Project	<b>IEEE 802.16 Broadband Wireless Access Working Group</b> < <a href="http://ieee802.org/16">http://ieee802.org/16</a> >	
Title	<b>Section 14.2.4.3</b>	
Date Submitted	<b>2007-01-11</b>	
Source(s)	Peretz Feder – ALU Philip Barber - Huawei	<a href="mailto:pfeder@alcatel-lucent.com">pfeder@alcatel-lucent.com</a> , <a href="mailto:pbarber@huawei.com">pbarber@huawei.com</a>
Re:		
Abstract	Changes to section 14.2.4.3	
Purpose	Adoption	
Notice	This document has been prepared to assist IEEE 802.16. It is offered as a basis for discussion and is not binding on the contributing individual(s) or organization(s). The material in this document is subject to change in form and content after further study. The contributor(s) reserve(s) the right to add, amend or withdraw material contained herein.	
Release	The contributor grants a free, irrevocable license to the IEEE to incorporate material contained in this contribution, and any modifications thereof, in the creation of an IEEE Standards publication; to copyright in the IEEE's name any IEEE Standards publication even though it may include portions of this contribution; and at the IEEE's sole discretion to permit others to reproduce in

**Figure 486 – Location Update Primitives**

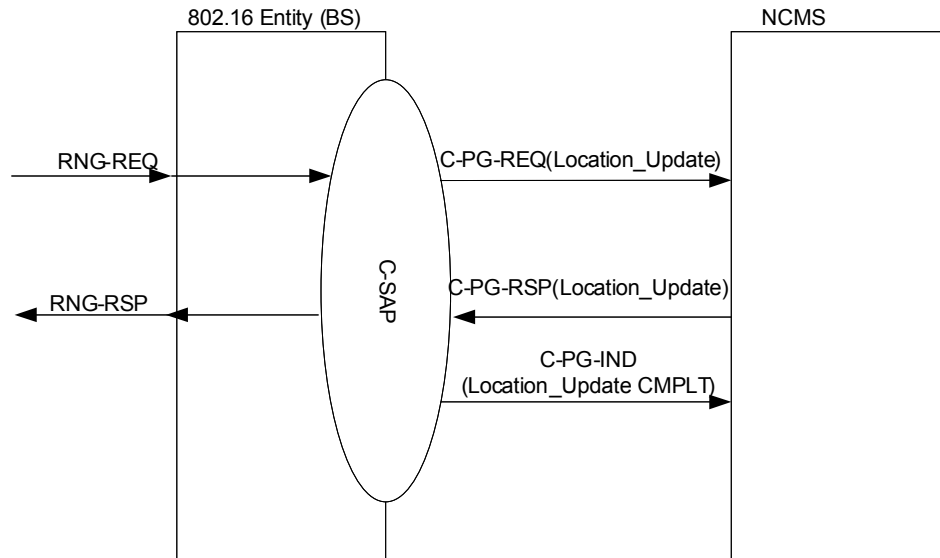
1 Correct Figure 486 and text in section 14.2.4.3

20 Figure 486 shows service primitives for Location Update between a BS and the NCMS.
